**NSLPP MEETING HELD ON 04/05/2022****Attachments:**

ADDRESS/WARD: 11 Bennett Street, Cremorne**APPLICATION No:** DA 353/21**PROPOSAL:** Demolition of existing structures and erection of an attached dual occupancy and associated works on each lot in an approved subdivision of the subject land into 2 lots (Consent DA 237/2018)**PLANS REF:**

OWNER: CMBR Marine Pty Ltd**APPLICANT:** CMBR Marine Pty Ltd**AUTHOR:** John McFadden, Consultant Planner**DATE OF REPORT:** 27 April 2022**DATE LODGED:** 29 October 2021**RECOMMENDATION:** Refusal

Figure 12: Western elevation of building W1/W2 - Plan DA11, showing blue dashed 8.5m height line and section of western building over the height limit, shaded yellow. (Mathieson Arch)

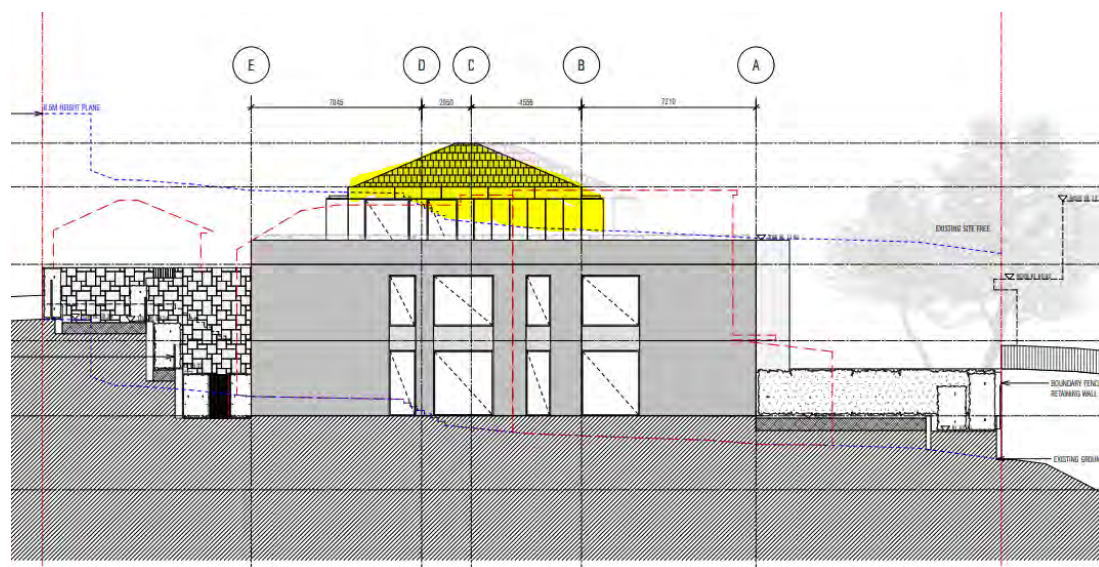
Further, the applicant's elevation and sections plans show 'existing ground shown dashed' in blue and RL 65.15 could be taken as a conservative estimate. This latter RL would closely equate to the location of the roof ridge of the proposed building, which is indicated as RL 75.60. Therefore the **western building will have an overall maximum height of around 10.4m** from the proposed ridge to the estimated 'ground level existing' below.

The building elements that exceed the LEP maximum building height are illustrated in **Figures 12 and 13** and described as follows:

On steeply sloping sites variations to the height development standard are often justifiable for minor projections to corners and roofs of buildings. However, in this case the topography has been already modified. Any breach to the development standard is not required to 'reflect the natural landform' or 'step' the development as the site has already been excavated for the tennis court and house. The breach to the development standard is merely to fit a third storey.

Figure 13: Eastern elevation of building E1/E2 - Plan DA13, showing blue dashed 8.5m height line and section of eastern building over the height limit, shaded yellow.(Mathieson Arch).

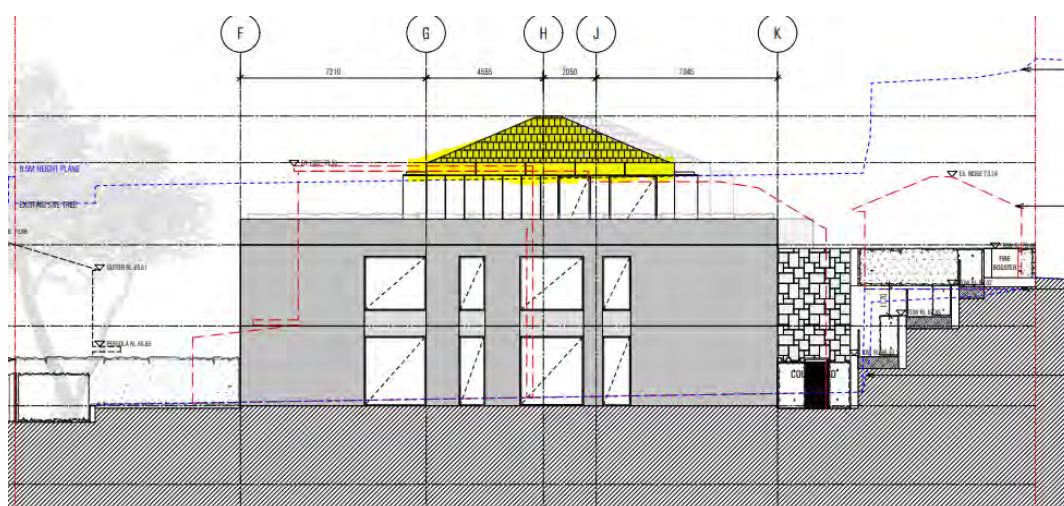
In the case of the proposed eastern Dual Occupancy, which will be built over the existing tennis court, the survey plan prepared by Frank M Mason & Co (surveyors) Plan 33267-12, indicates spot levels of the 'existing ground level' on the tennis court ranging from RL 64.89 towards the north (Bennett Street) to RL 64.53 to the south (rear), and in the central portion of the tennis court as RL64.61.

Figure 15: View from inside No. 20 Bennett kitchen/dining room towards CBD.

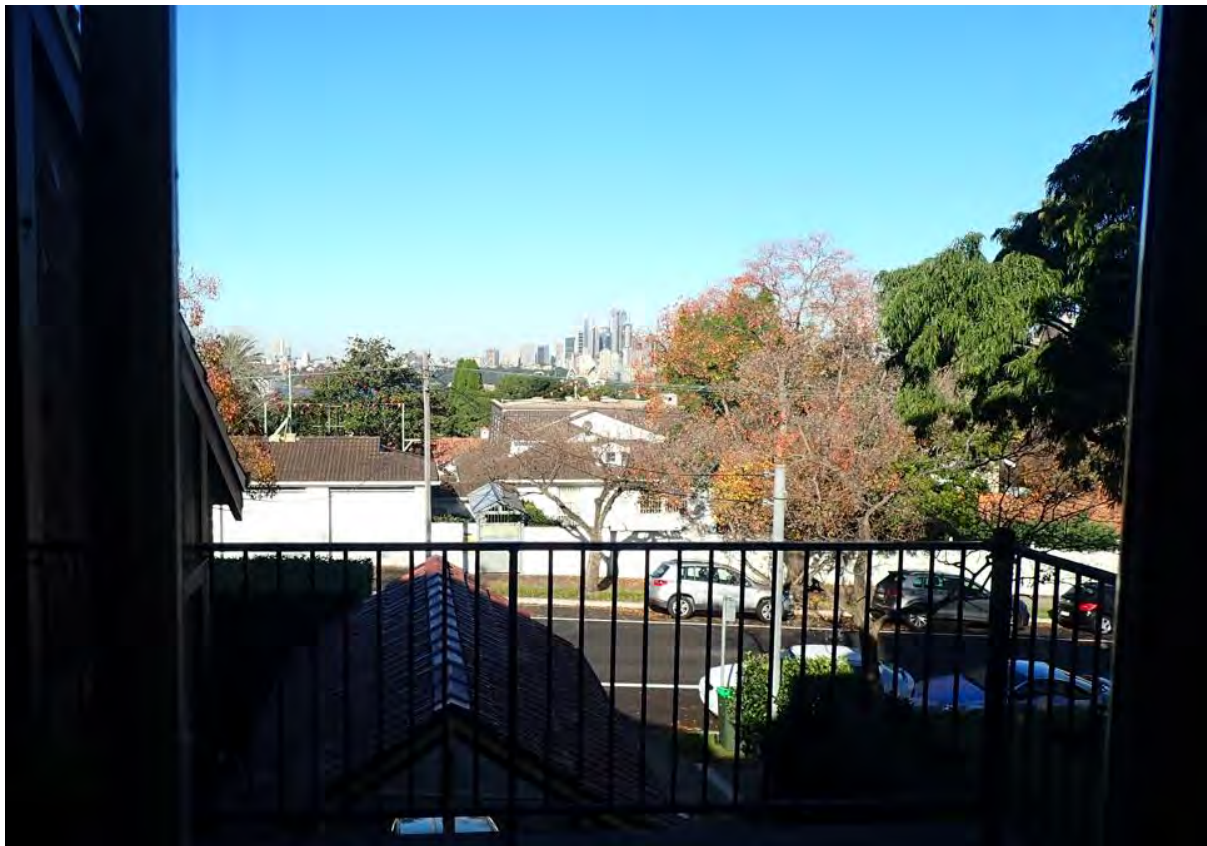
Figure 14 shows two of the properties whose views are impacted to various degrees by the current height of the proposal. **Figures 15 to 18** shows the views from No. 20 Bennett Street and although existing vegetation partially filters these views, the current proposal, being higher than the previous refused DA308/20, will impact views as a result of the increase in height variation proposed.

Figure 16: View from balcony of No. 20 Bennett towards CBD showing upper sails of the Opera House.

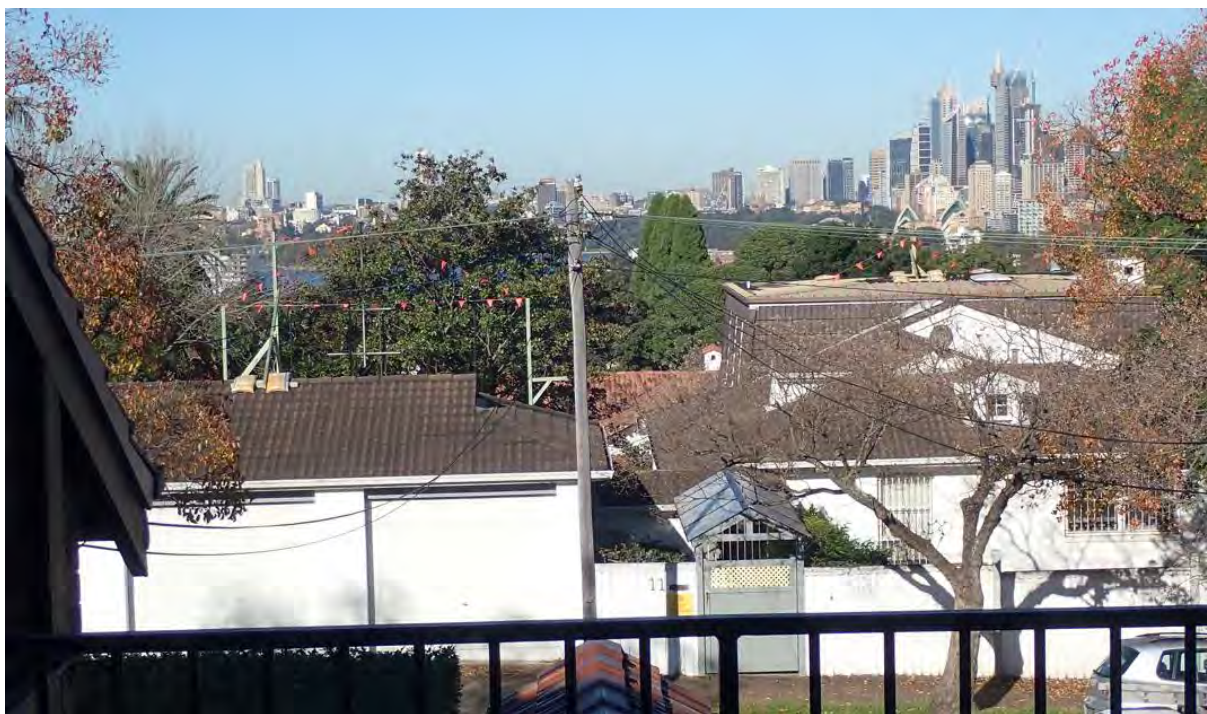
The views in question are from the front of the house, from both sitting and standing and from high activity rooms and areas ie; kitchen, dining and its balcony and to a lesser extent, the lounge room (as this view is 'filtered').

Figure 20: Existing and proposed shadows cast by the proposed development 9am June solstice.

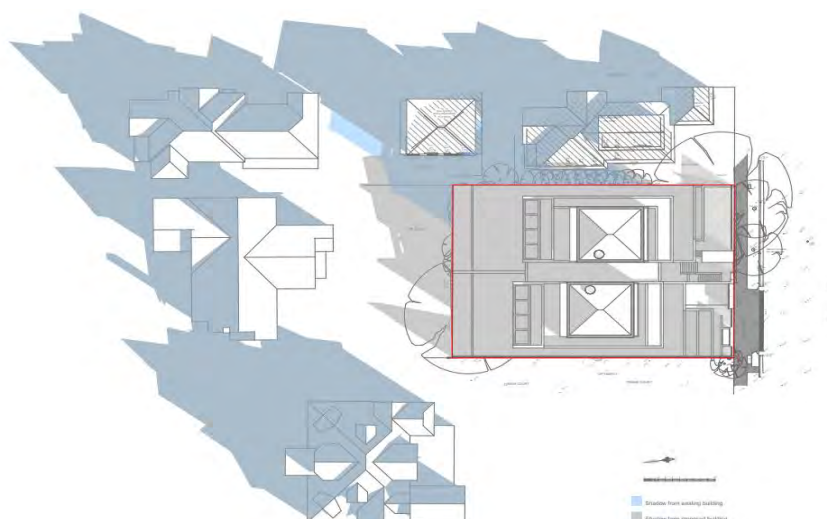
The shadow diagrams submitted with the proposal indicate that morning midwinter overshadowing will occur to the dwelling houses to the west (Nos. 19 & 21 Burroway Street) and the rear garden of the adjoining Heritage Item to the south, No. 4 Bertha Road. At midday, the sun will be sufficiently high enough so that only minor shadowing to the rear garden of Bertha Road will occur. **(Figure 20)**

Figure 21: Existing and proposed shadows cast by the proposed development 3pm June solstice.

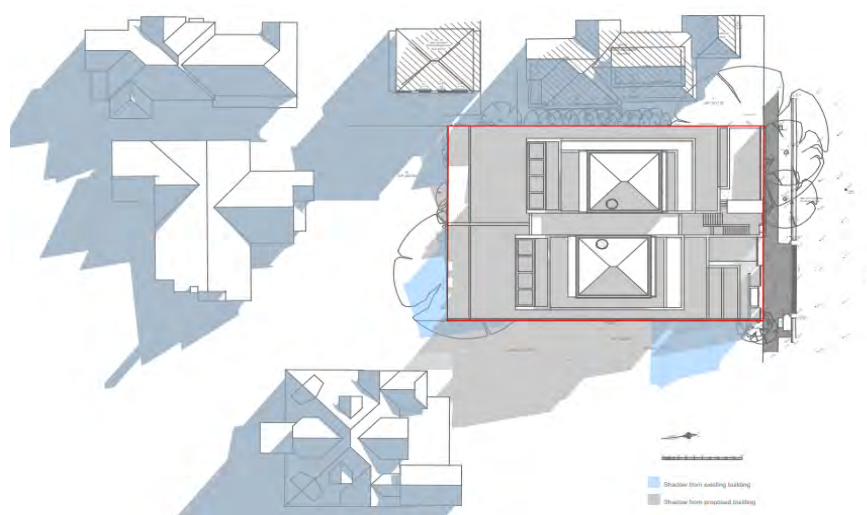
In the afternoon however, the other adjoining Heritage Item 'Ingleneuk', at 19 Bennett Street will experience shadowing of the rear garden and tennis court with shadows extending up to the northwest corner of the house.

Whilst even 8.5m high complying two storey development would cast some additional, and perhaps unavoidable shadowing, the variations to the height development standard proposed by the 3 storey development unnecessarily exacerbates the impact of any overshadowing and reduces solar access to adjoining properties.

**Figure 22: Excerpt of isometric view of height variation from NW
(Plan DA 31 Mathieson Arch)**

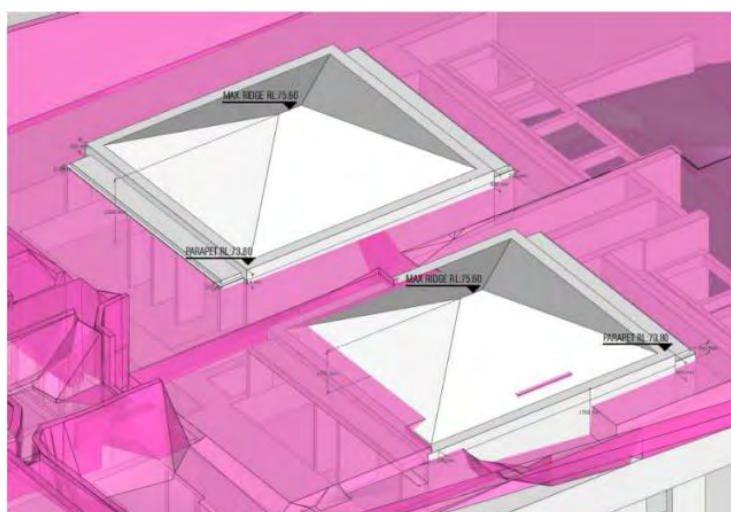
The submitted clause 4.6 report and plans illustrate the proposed non-compliances as follows (refer to Figure 22 below). (Figures 12 and 13, within this report give another, elevation view of the level of the height variations).

Figure 27: West Elevation displaying the roof which appears to be a minor element of the overall design (Plan DA11 Mathieson Architects).

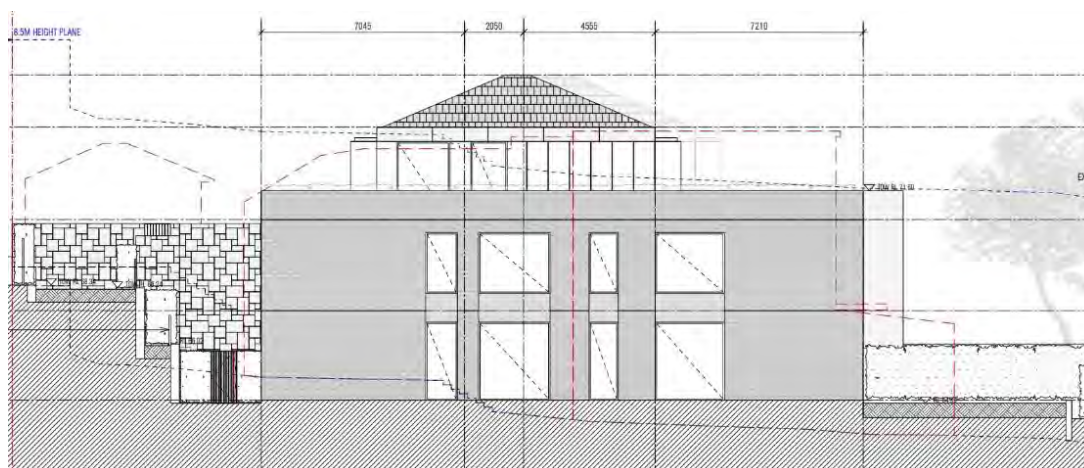
It is not considered the 'proposed strong pitched roof' claimed is, a strong pitched roof form. It is a shallow (22.5 degree) hipped roof which appears as an 'add on' or an afterthought element to an otherwise flat roof house design.
